# Viaducts, Eastern Core and False Creek Flats Cycling Improvements

HUB Vancouver/UBC committee  
2013/05/13

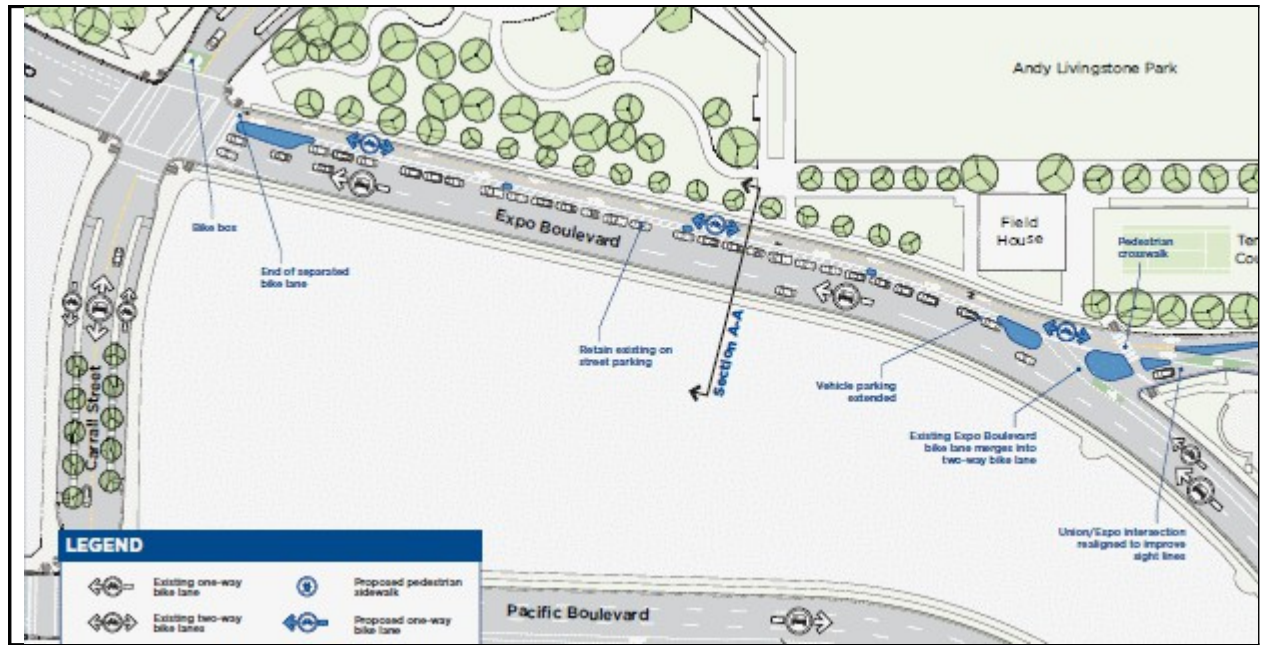
HUB Vancouver notes that the Cycling Bridge, while intended only for cycling, could attract pedestrians looking for a quick walking route between Dunsmuir Street and Pacific Boulevard. This could be problematic, especially when events are being held at GM Place. Room for walking, therefore should be incorporated into this bridge with separation of the two modes.

If possible, the grade of the Cycling Bridge should be less than 5%, with 3% ideal. Research indicates that steeper downhill grades and the higher resulting speeds are more dangerous for cyclists (and pedestrians) should a collision occur. Braking distances are longer and the cyclists centre of gravity is further forward meaning that if a cyclist suddenly brakes, there is a greater chance of the them falling over their handlebars and landing on their head. Cyclists heading downhill may be reluctant to stop at Carrall for crossing bicycle and pedestrian traffic, thus creating potential conflicts and collisions. Resist the temptation to shorten the cycle bridge as this will make the grade steeper. A low grade is important for accessibility. There could even be two ramps up to the cycle bridge each at a different grade. The hill of Andy Livingstone Park (if it is to stay) could be incorporated into the cycle bridge ramp.

One option would be to retain more of the Viaduct on Dunsmuir Street, close to GM Place, and extend the landing point of the Cycling Bridge to the east of Carrall Street. The benefit is that cyclists would not have to cross Carrall at grade.

HUB Vancouver proposes a fork of the Cycling Bridge for cyclists and pedestrians. This fork from the proposed Cycling Bridge would run along the north part of the guideway (perhaps even attached as on the Canada Line bridge) to south of where the SkyTrain dips as it crosses Expo. It would allow cycling access between the Seawall up to Dunsmuir Street without requiring

In line with the weather protection offered by the SkyTrain guideway, the screen proposed for the Cycling Bridge could be changed to a weatherproof material. This would also help prevent ice from forming in some conditions, making it safer.

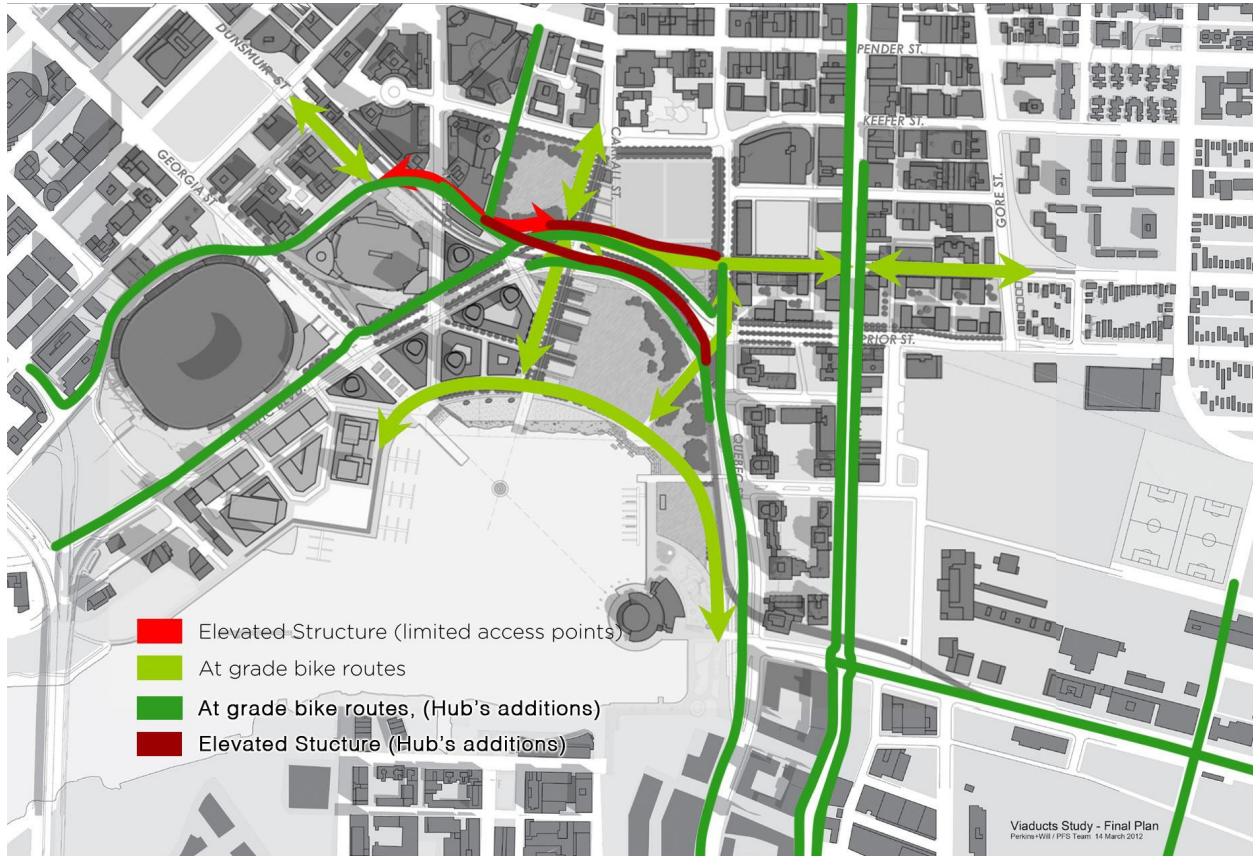
- Make extra space to accommodate two-way bike lane on the north side of Expo Boulevard Between Quebec and Abbott.
- Add a new separated bike lane on Expo Boulevard between Abbott to Cambie by BC Place.
- Add a new separated bike lane from Abbott to Carrall under the proposed Cycling Bridge.
- Relocate the proposed bicycle and pedestrian paths along New Street under the SkyTrain guideway.
- Add a new cycle lane on Taylor Street and add cycle paths from Keefer Street to Expo Boulevard.
- Add a new two-way separated bike lane on New Street between Carrall and Cambie.

- Potential cyclist-pedestrian problems on the Cycling Bridge.
- The grade on the Cycling Bridge should be less than 5% and ideally 3%.
- A proposal to land the Cycling Bridge east of Carrall Street at its eastern end.
- A proposed southern fork off the Cycling Bridge towards its east end.
- Weather protection at the western end of the Cycling Bridge.

the Cycling Bridge and its southern fork should extend. The map shows the Cycling Bridge extending as far east as Quebec, whereas some in HUB propose that the Bridge extend just a little east of Carrall Street. The map also shows the southern fork extending almost to Quebec whereas some in HUB suggest the southern fork extend down to either just west or east of Carrall.

### **Relocate Proposed Bicycle and Pedestrian Paths Along New Street Under SkyTrain Guideway**

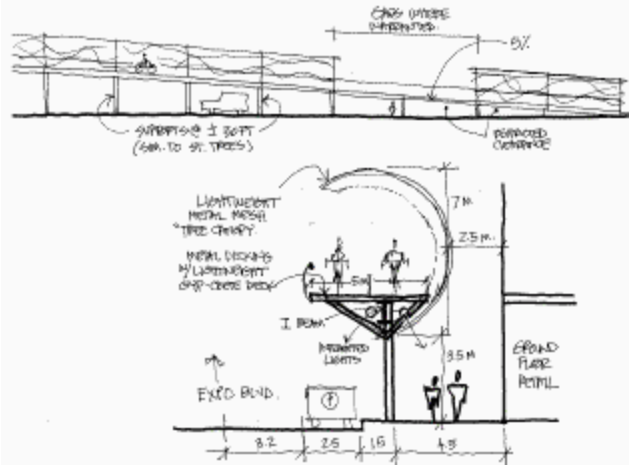
HUB Vancouver suggests relocating the bicycle and pedestrian paths, currently proposed for the north of the guideway along New Street, to underneath the guideway where height allows this.

As the guideway runs east-west in general and the proposed sidewalk and bike lane along New Street are to the north of the guideway, the current proposed locations right adjacent to the road will be shaded by the guideway much of the year and the guideway will occupy much of the field of vision to the south. In addition to providing weather protection, placing the bicycle and pedestrian paths underneath the guideway will give cyclists and pedestrians more light and a much better view to the south. This would also provide much more separation from the noise and pollution of traffic, making walking and cycling much more pleasant. Where the Skytrain guideway dips down, the cycle path can veer to the south side. This section could have a rain cover incorporated into any access prevention that is needed for the Skytrain guideway.
